**The Plan Change 14 Part C Technical Report has No Ecological Assessment for the Mature Native Trees**

## Proposed Cell C4 has Mature Trees located alongside Lake, at the Southern End

# The Ecology Technical Report for Cell C4

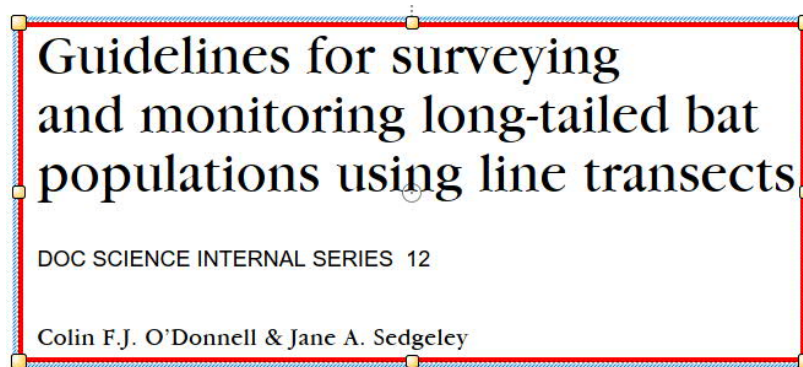
1. This Report **only** provides a Site Inspection Report
2. There are only Visual Inspections of the Aquatic Life
3. There is **No** Consideration for Bats and their Habitat

1. A Bat Survey carried out to DOC Guidelines
2. Mitigation and or Translocation site provided before any Construction Activities

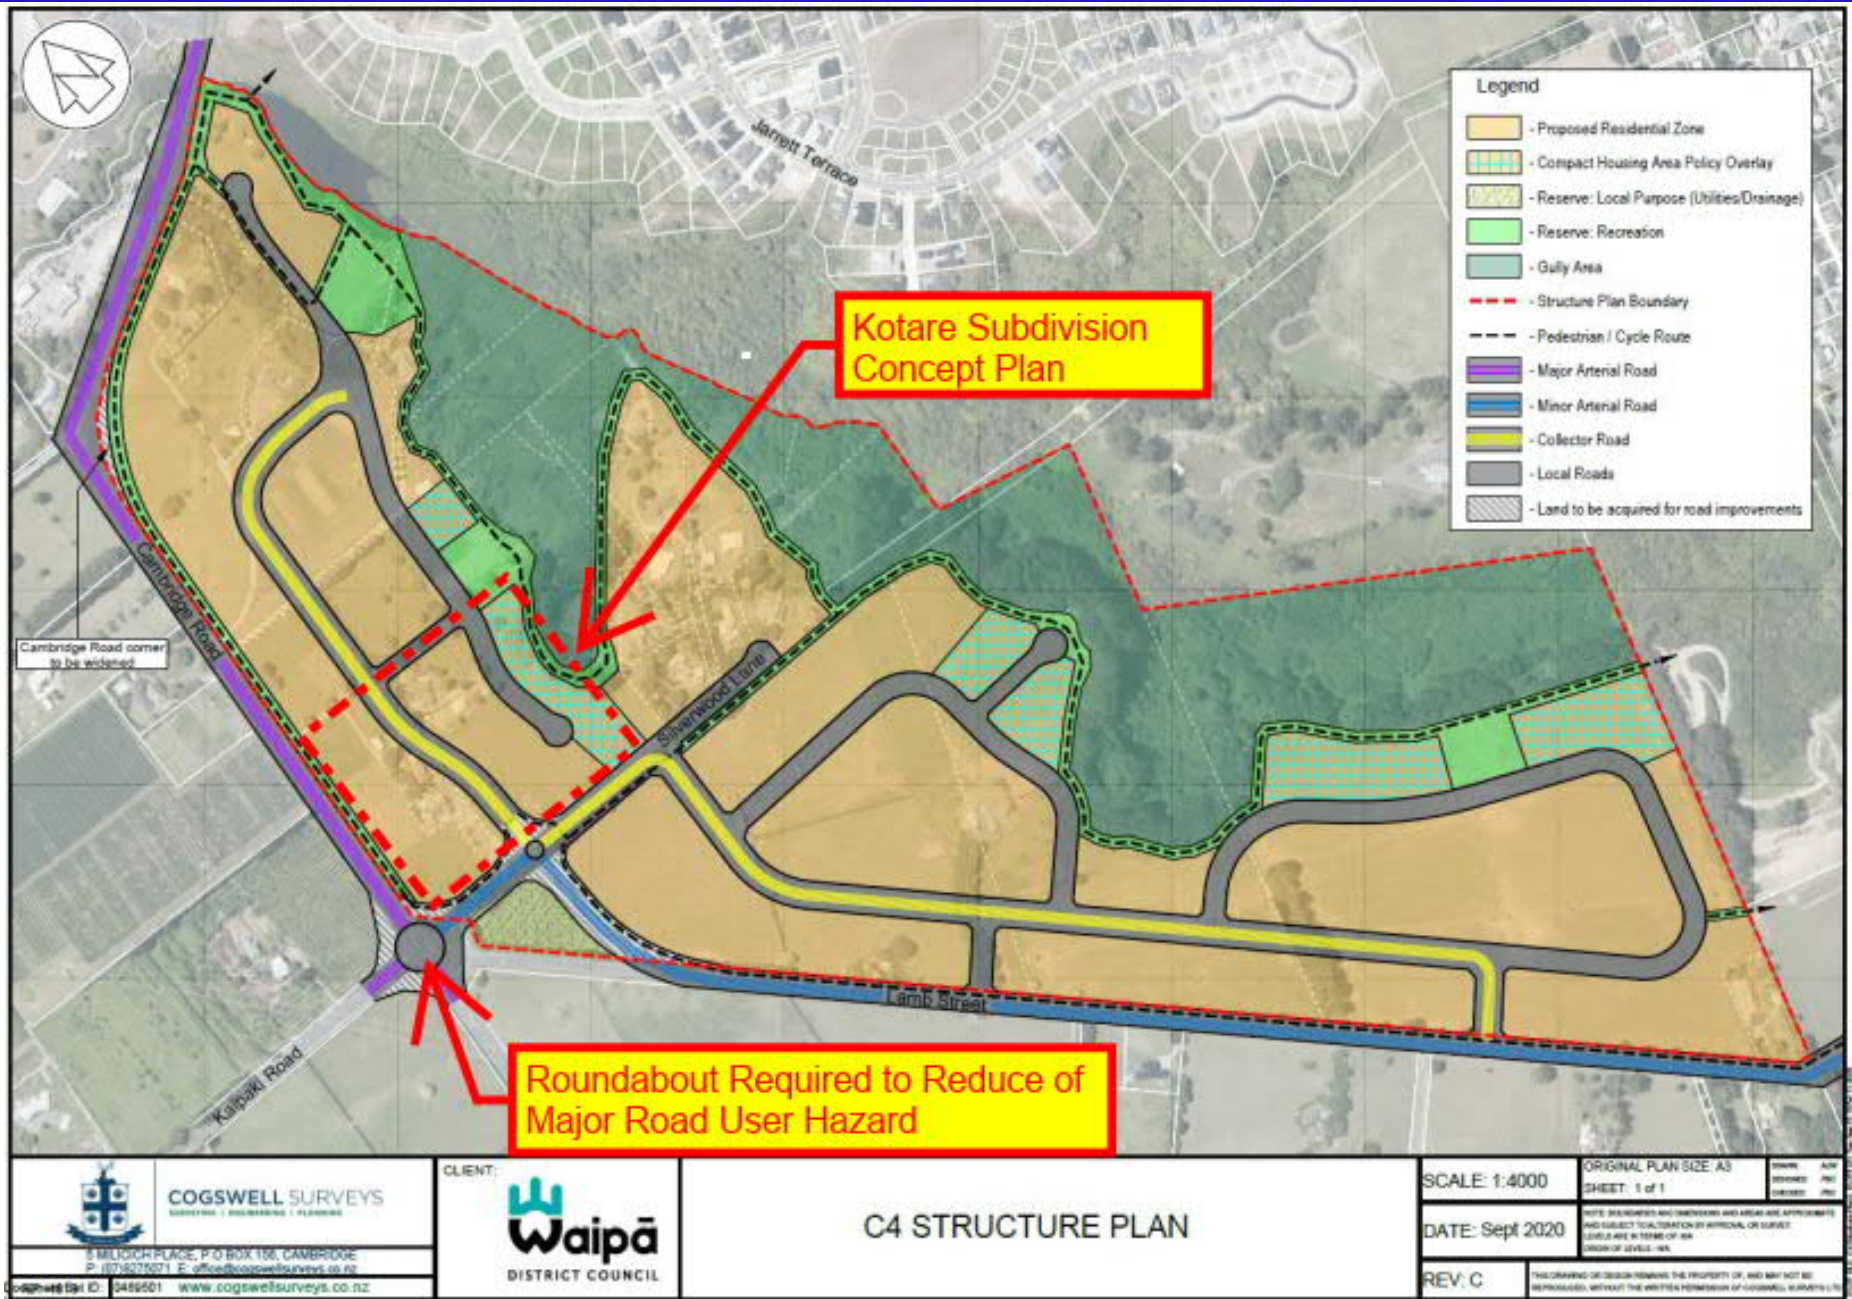
The Water Supply and Fire Main pressure are essential for public safety. The Plan Change 13 does not include the provision of new trunk mains and water treatment plants as a pre-requirement to the Plan Change Approval.

The testing of all elevated Fire Hydrant locations is required to unequivocally demonstrate that the existing water supply network meets the New Zealand Fire Service Firefighting Water Supplies Code of Practice. This testing needs to be carried out to the attached Appendix G -SNZ PAS 4509-2008.

This testing then needs to be modelled in a verified network model with the proposed additional sub division cells included to demonstrate that the public safety has not been adversely affected.

The Developers Contributions need to be re-evaluated to address any capital investments that are required to provide the legal Fire Main requirements. The existing \$65,000 per building plots need to be validated in an audited business case model as these contributions are potentially substantially inadequate. Current Waipa ratepayers cannot be penalised for any Council sub-division approvals that have not been accurately assessed. Detailed Engineering Requirements need a detailed cost estimate and an audited Financial Developer Contributions Report.
